BLDG 3 FIRST FLOOR PLAN - AREA 1

PROJECT TITLE	SLIVICS REPLACEMENT MEDICAL CENTER PROJECT		
LOCATION	NEW ORLEANS, LOUISIANA		
DATE	February 29, 2012	DIRECTED BY	ML
		DESIGNED BY	ADD/MDM

PROJECT NUMBER 629-HSZ-401	BUILDING NUMBER 03	DOCUMENT REFERENCE WPA-08	DRAWING NUMBER 3A1101-H	 Department of Virginia

BLDG 3 OVERALL SIXTH FLOOR PLAN	
APPROVED PROJECT DIRECTOR

1 BLDG 3 OVERALL SIXTH FLOOR PLAN

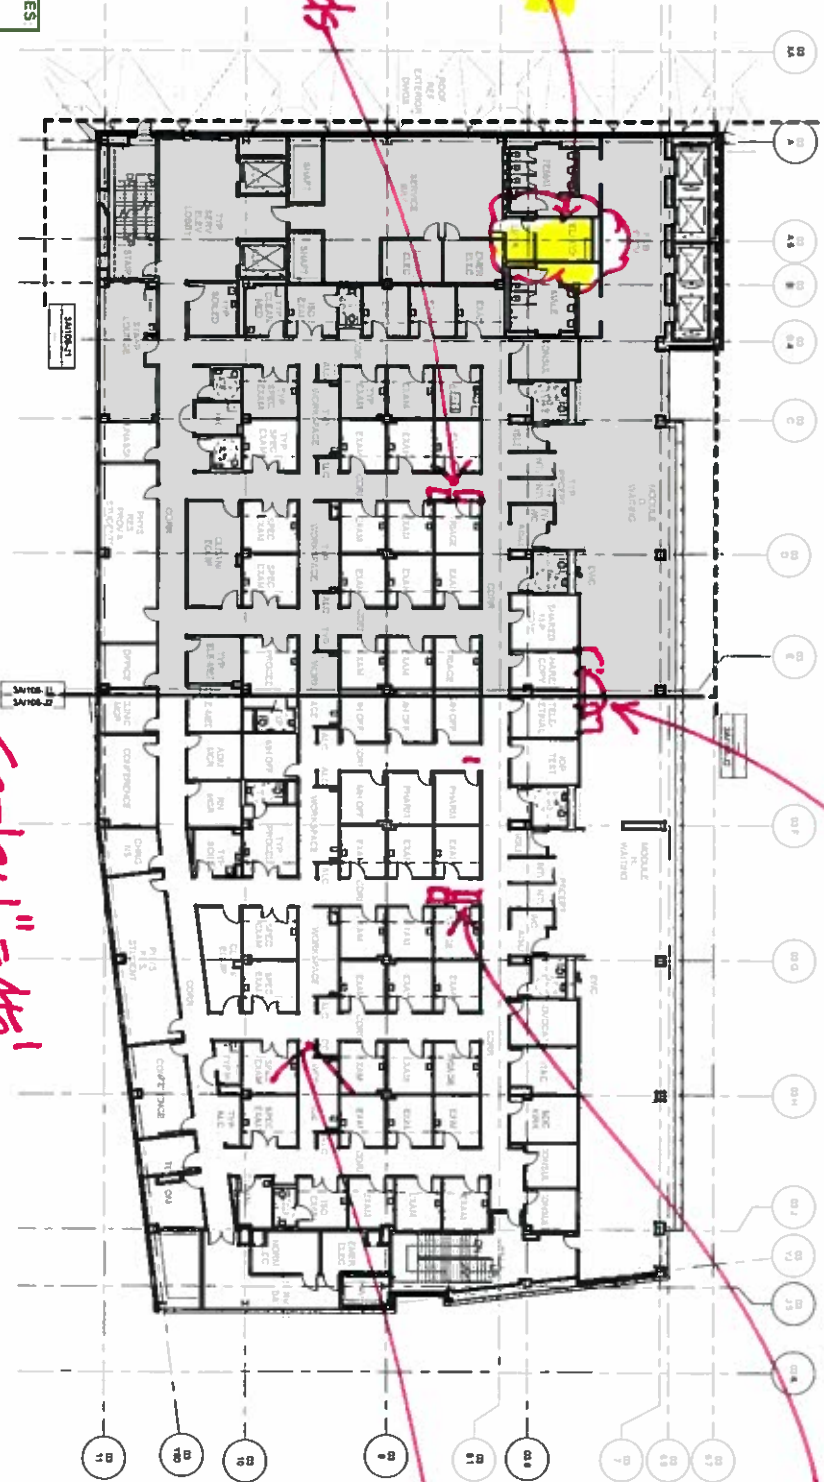
REFER TO THE FOLLOWING SKETCH FOR CHANGES
SK-8-4-NJ 3A1106

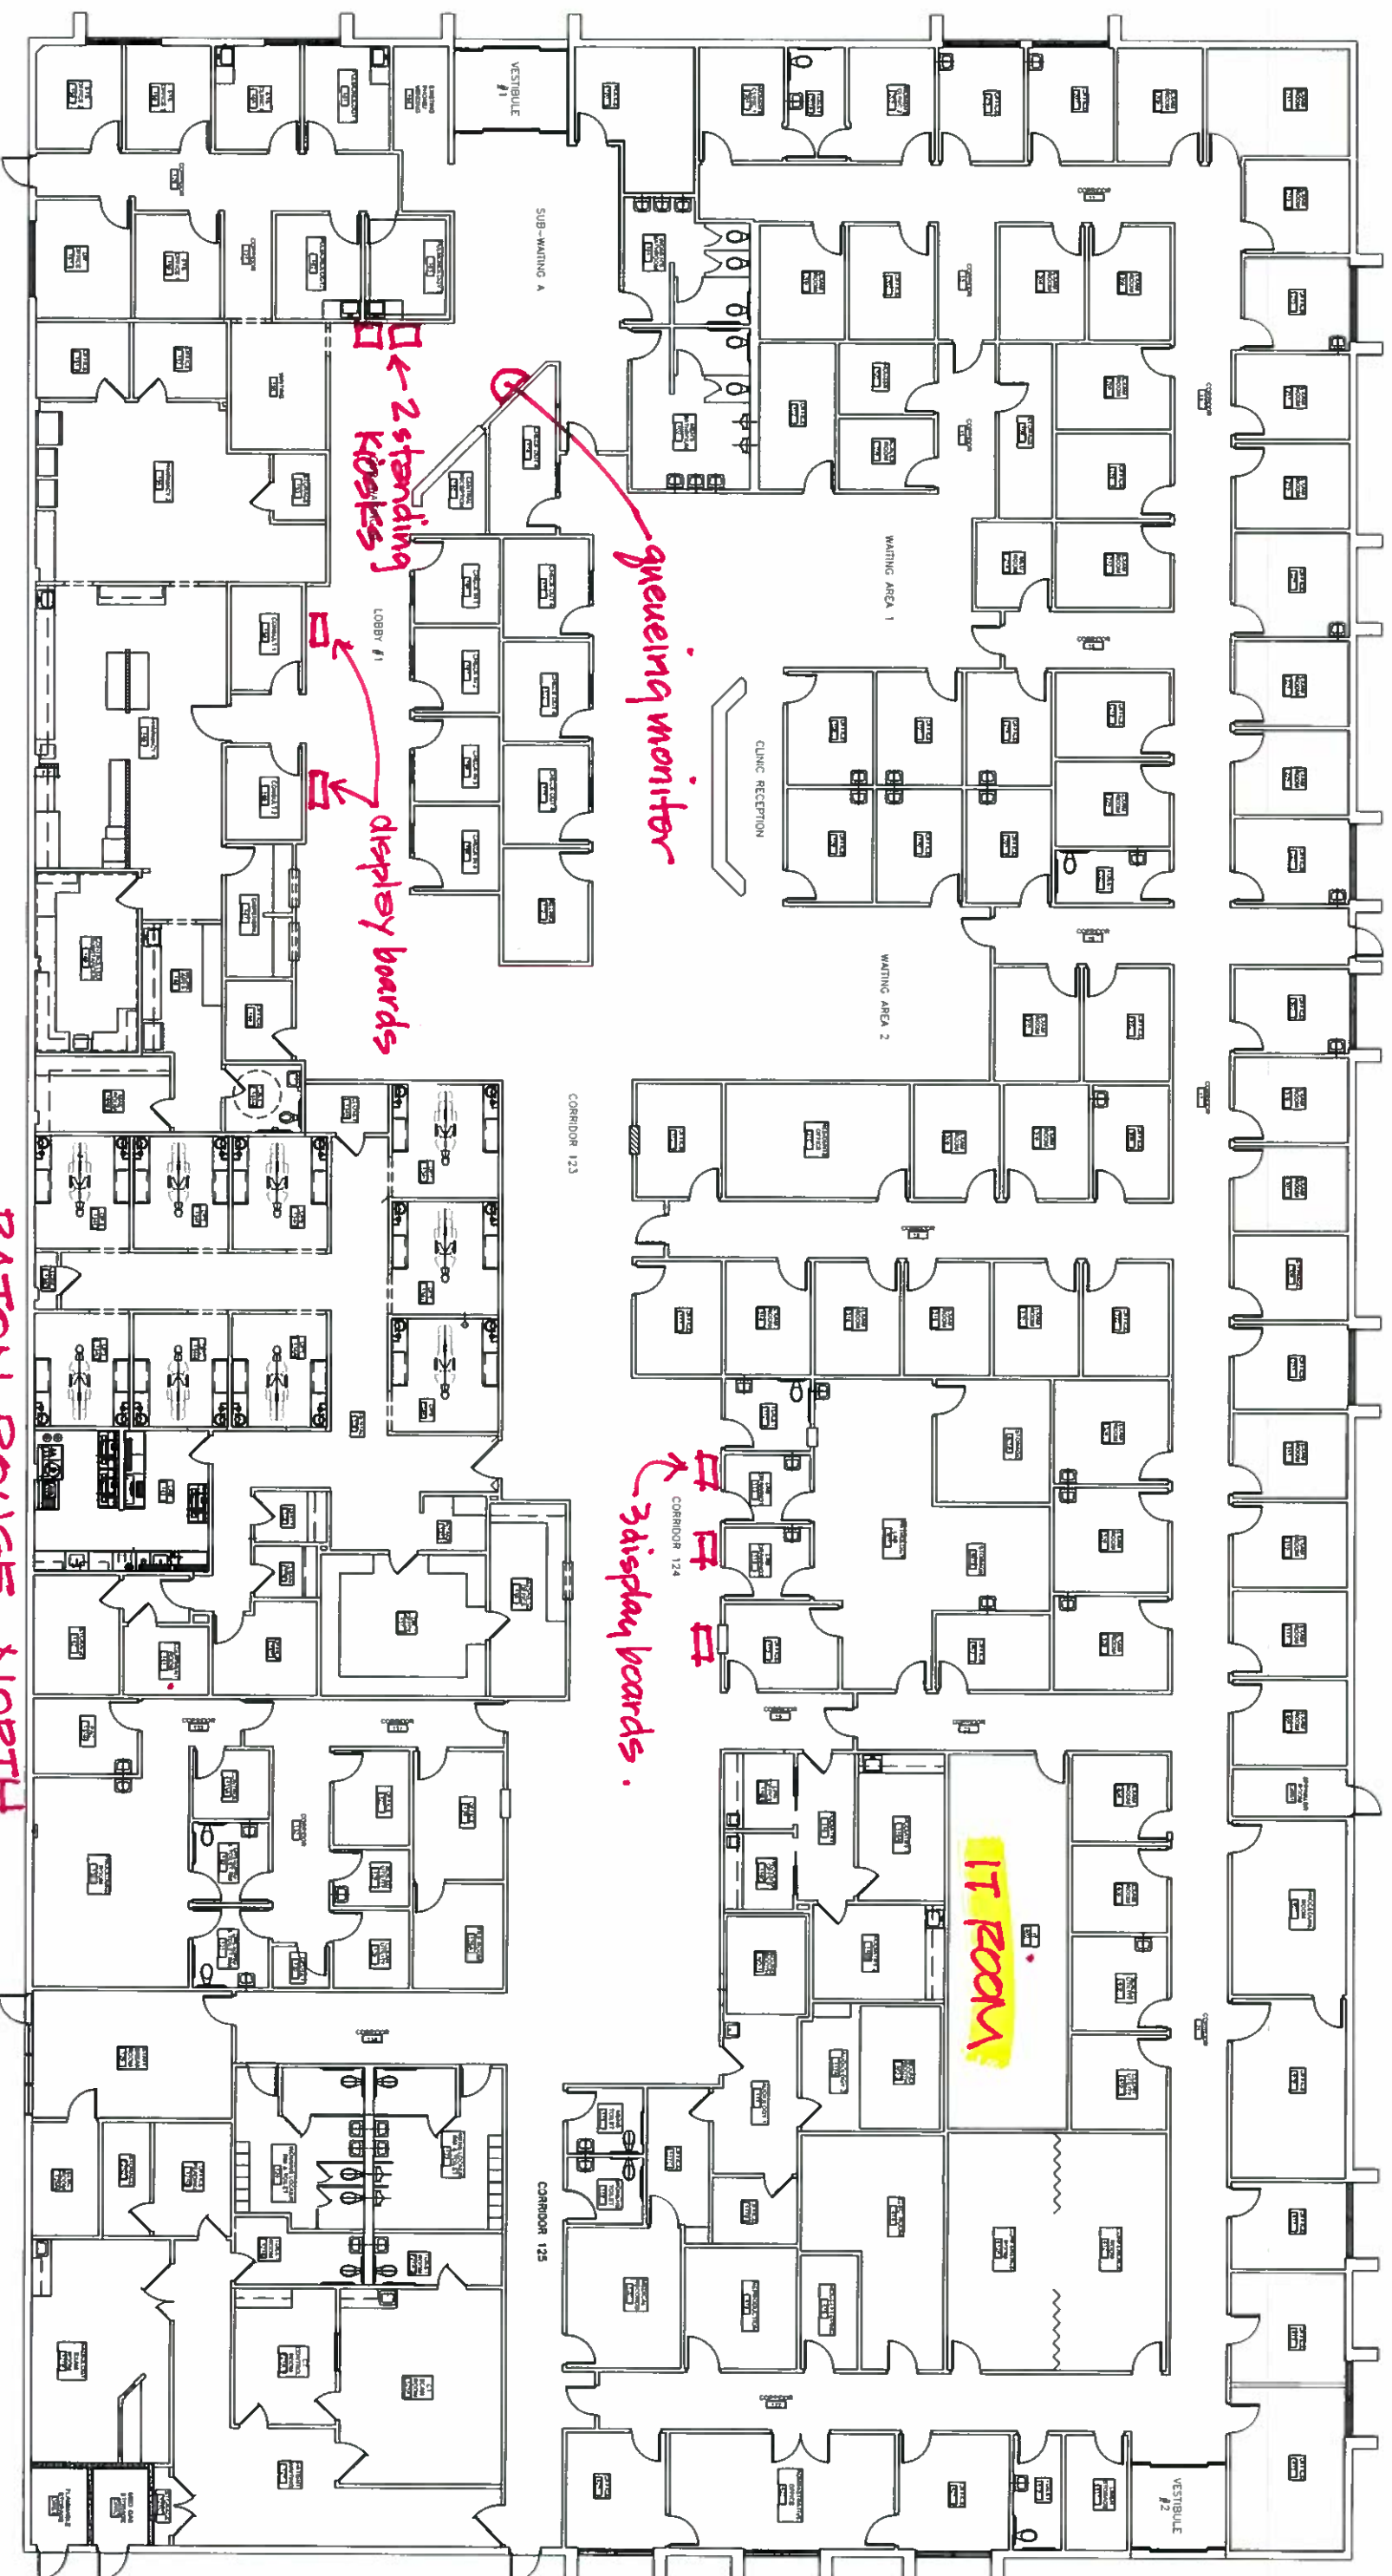
RFI 07212.1: All exterior walls where J-4 walls were deleted and more than 3/4" of fire safing is exposed to be handled per RFI.
